TWEED VALLEY HOSPITAL NSW

ARCHITECTURAL AND URBAN DESIGN RESPONSE TO
EIS AND SSD STAGE 1 APPLICATION SUBMISSIONS

24 JANUARY 2019

FIGURE 01 - PROPOSED INDICATIVE PEDESTRIAN NETWORK

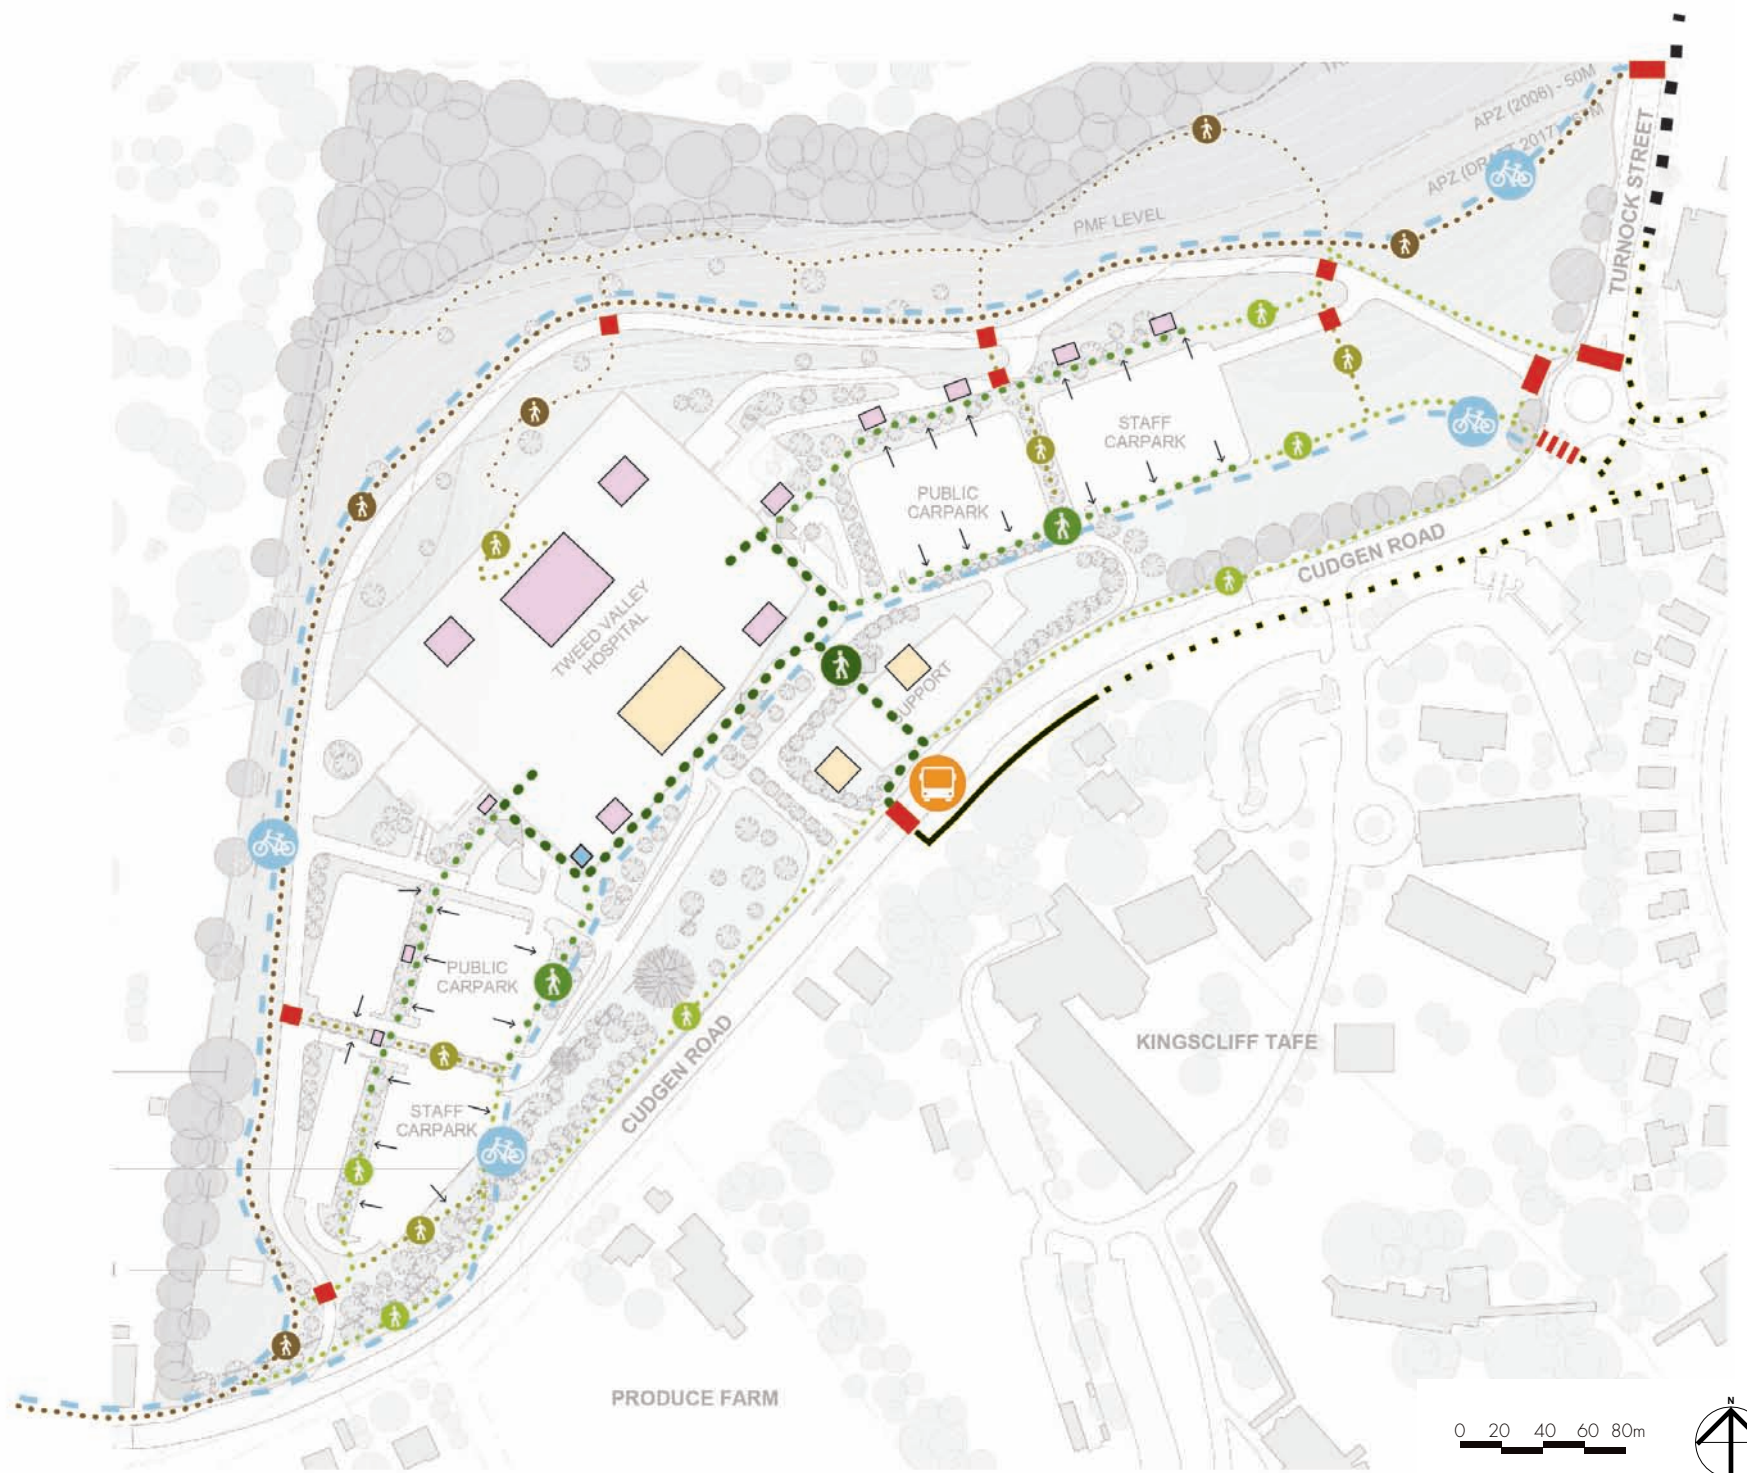
- **a ground level plan that identifies and prioritises a hierarchy of open space.**
- **the Cudgen Rd setback zone as an amenity for the community, workers and visitors alike.**

- **a coherent and connected street network that creates a framework for future development**
- **priority given to pedestrian amenity**
- **accommodates multiple modes including pedestrian, bicycle and public transport movements**

It is recommended that the master plan more clearly articulate internal roads and streets which organise and structure the site's future building envelopes, vehicular circulation, car parking as well as clearly delineated pedestrian (shaded) and cycle movements across the site, open space and public domain areas. Similarly, a location for public transport access (bus stop) should be nominated and relate to the surrounding context (residential and TAFE). It is further noted that the location of the car parking areas, which dominate a substantial portion of the site's area are a substantial uncovered walking distance from the main hospital access points. Given the site's slope, there is good opportunity to locate car parking in building envelopes undercroft areas and provide vertical circulation to access different hospital and health services.

Concept Landscape strategies have been developed since the initial Consultation Session on October 2018, which have been illustrated in the appended revised Landscape Zonal Plan and fig.01 Proposed Indicative Pedestrian Network drawings, as part of the Architectural and Urban design Response to Submission Report.

Priority is given to pedestrians as described in the Landscape Pathway Network drawing, refer fig.01 appended, which include connection with a conceptual network of complementary public spaces. This plan identifies the following pathway networks;

- Main pedestrian route from site entry (public bus stop) to hospital entry
- Secondary pedestrian route along public hospital street
- Dedicated pedestrian route/spine running east to west through the site connecting all carparks and hospital entrances. This access spine can be extended to the east to support future complimentary program development.
- Connector Pedestrian paths connecting the above routes
- Informal pedestrian trail along the landscaped northern part of the site.

Multiple modes of transport are accommodated as described in the Landscape Pathway Network drawing, including the integration of bus stop and cycle routes.

The site access and internal road network design engineering justification has been provided with the submitted EIS and accompanying Appendix L Traffic Impact Assessment. An indicative pedestrian pathway plan has been provided at fig.01 appended. Design provision of sheltered walkways providing access from the surface carparking to the hospital entrance will be included and documented in the Stage 2 SSD application.
